SUNDRY NOTICES AND REPORTS ON WELLS

Mewbourne Oil Company requests that the following changes be made to the approved APD for the Yardbirds 34/3 Fee #711H (API: 30-015-55113):

¹ API Number	² Pool Code 98220	³ Pool Name PURPLE SAGE; WOLFCAMP GAS
⁴ Property Code	⁵ Property Name YARDBIRDS 27/3 FEE	⁶ Well Number 711H
⁷ OGRID NO. 14744	⁸ Operator Name MEWBOURNE OIL COMPANY	⁹ Elevation 3036'

WELL LOCATION AND ACREAGE DEDICATION PLAT

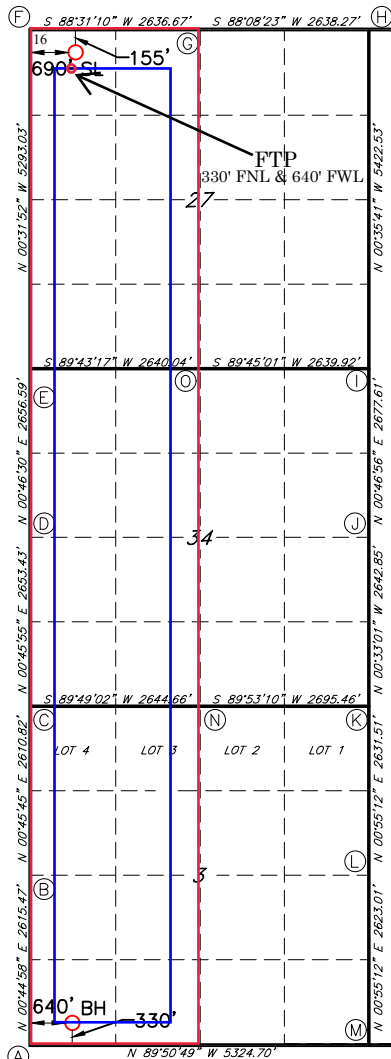
- Change well name from Yardbirds 34/3 Fee #711H to Yardbirds 27/3 Fee #711H.
- Change SHL from 2400' FSL & 1800' FWL (Sec 34) to 155' FNL & 690' FWL (Sec 27).
- Change BHL from 330' FSL & 650' FWL (Sec 3) to 330' FSL & 640' FWL (Sec 3).
- Change Surface Casing set depth from 1200' to 450'.
- Change Production Casing from 7" 26# P110 LTC to 7 5/8" 29.7# HCP110 GBCD.
- Change Liner from 4.5" 13.5# P110 LTC to 5.5" P110 Talon.

UL or lot no.	Section	Township	Range	Lot Idn	Feet from the	North/South line	Feet From the	East/West line	County
D	27	23S	28E		155	NORTH	690	WEST	EDDY

UL or lot no.	Section	Township	Range	Lot Idn	Feet from the	North/South line	Feet from the	East/West line	County
M	3	24S	28E		330	SOUTH	640	WEST	EDDY

Yardbirds 27/3 Fedd #711H

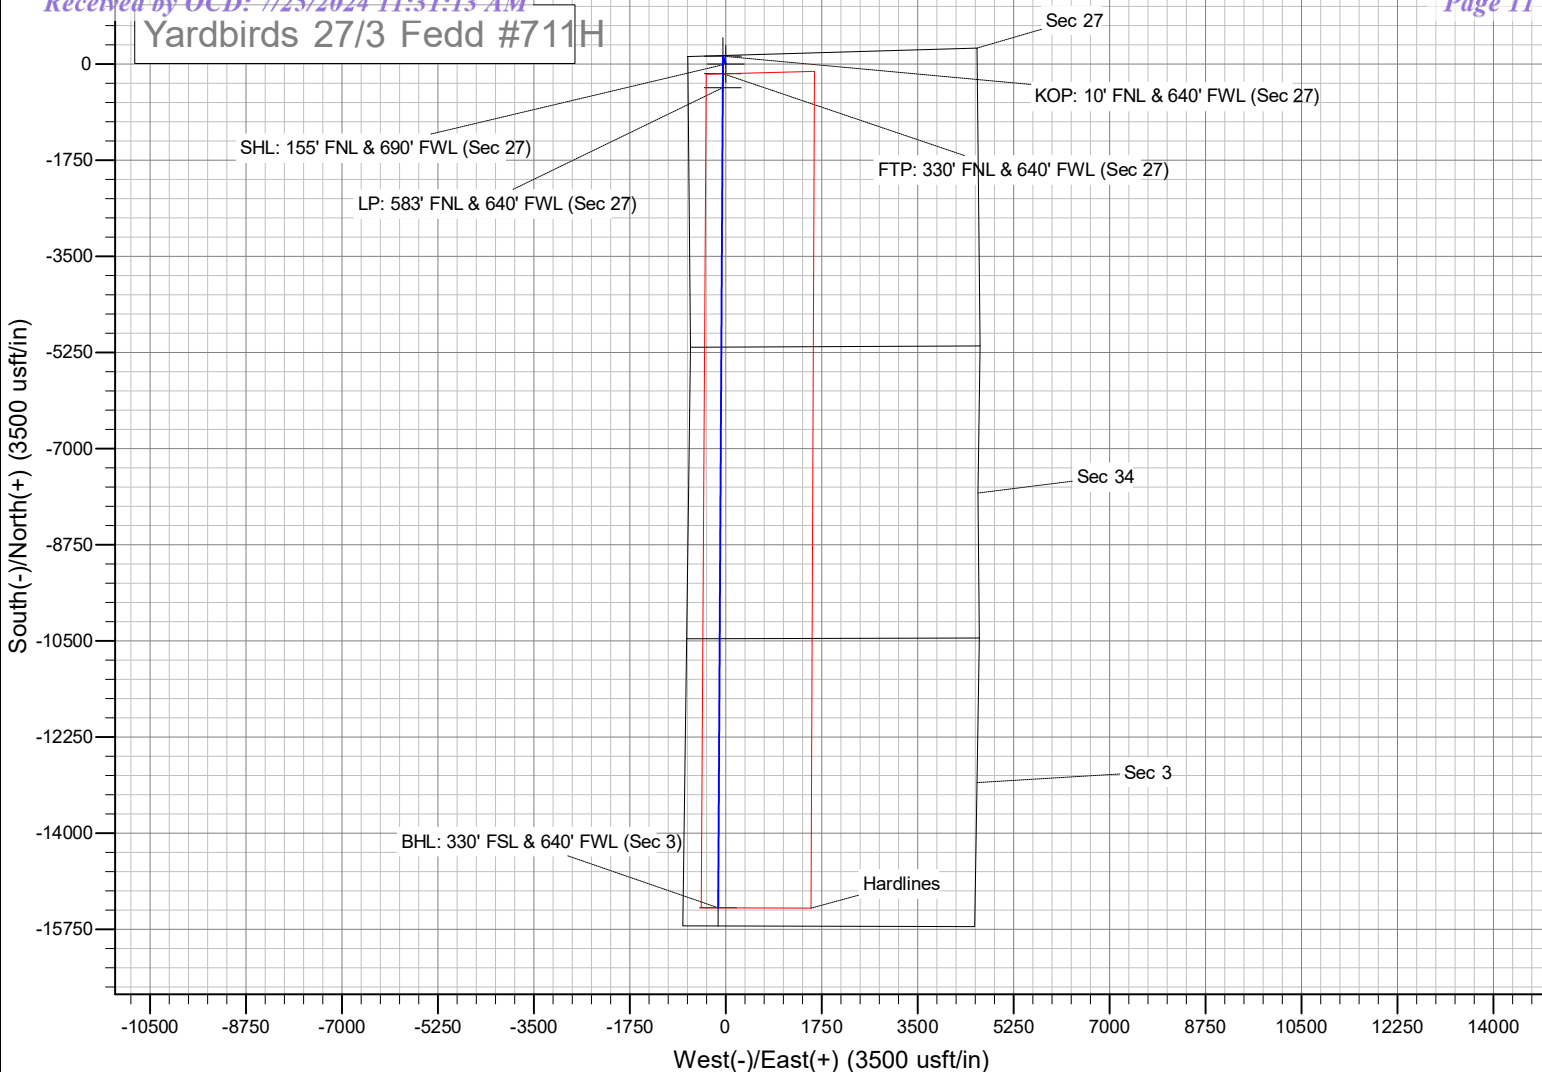
Attached is the C102, Casing Assumptions, Directional Plot and Plan that details the above changes.

Created By	Condition	Condition Date
ward.rikala	All original COA's still apply. Surface casing must be sat and cemented a minimum of 20' into the Rustler formation. Additionally, if cement is not circulated to surface during cementing operations, then a CBL is required.	8/15/2024
